CITY OF
**West
Linn**

DR-15-11/LLA-15-01

Staff Presentation for ConAM Properties LLC applications for
Design Review and Lot Line Adjustment

Traffic Impact Assessment - mitigation

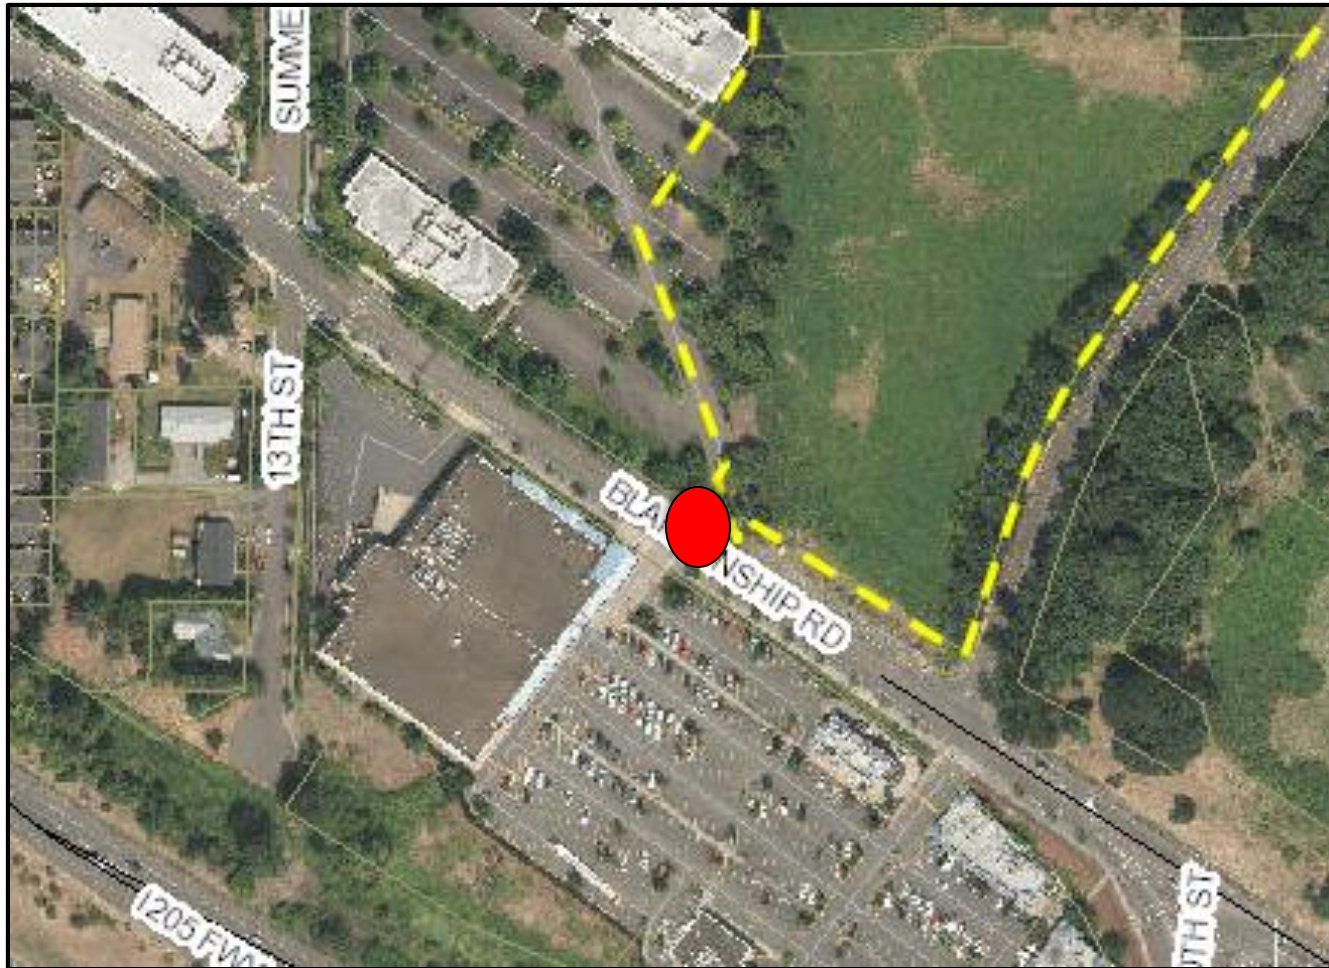
1. Install a median on the Tannler Drive approach to Blankenship Road to limit southbound traffic to right turns only. No restrictions are proposed for the Haggen Shopping Center driveway, and left turns from Blankenship Road eastbound to Tannler Drive would still be allowed. See Figure 3.

2. Signalize the Site Access/West Haggen Driveway intersection with Blankenship Road to accommodate the increase in left-turning vehicles from the site and enhance the pedestrian crossing of Blankenship Road.

3. Provide a second left-turn lane on the Salamo Road approach to 10th Street by widening the roadway and intersection and installing necessary traffic signal equipment. No changes are proposed to the signal timing or phasing. The two left-turn lanes should provide 225 feet of storage. See Figure 4.

4. Pay a proportionate share, in the amount of \$24,010, towards the cost of improvements at the 10th Street/8th Avenue/8th Court intersection and the 8th Court extension. (No change from TIA.)

- COA #10 – **Traffic Mitigation:** Complete the four recommended mitigations on Page 5 of the on the Mackenzie letter revised August 25, 2015.
- COA #11 – **Tannler Drive Improvements:** The Applicant shall install a sidewalk and street trees along the frontage of Unit 2
- COA #12 – **Engineering Requirements:** The Applicant shall submit updated engineering plans that show required on- and off-site improvements

- COA 13: The applicant shall:
 - a. Install a median on the Tannler Drive approach to Blankenship Road to prohibit southbound left turns;
 - b. Install a signal at the Site Access/West Haggen Driveway intersection with Blankenship Road and enhance the pedestrian crossing of Blankenship Road;
 - i. Prior to issuance of the first building permit the applicant must submit plans for the signal to the City Engineer, and
 - ii. The signal must be installed and operational prior to issuance of the first certificate of occupancy on the site.

- COA 13: The applicant shall:
- c. Widen the roadway and intersection and construct a second left-turn lane, and install necessary traffic signal equipment on the Salamo Road approach to 10th Street.
- This condition does not preclude the issuance of SDC credits to the applicant if any of the facilities are approved for such credits.

- COA 14: The applicant shall pay \$24,010 for improvements at the 10th Street/8th Avenue/8th Court intersection and the 8th Court extension.
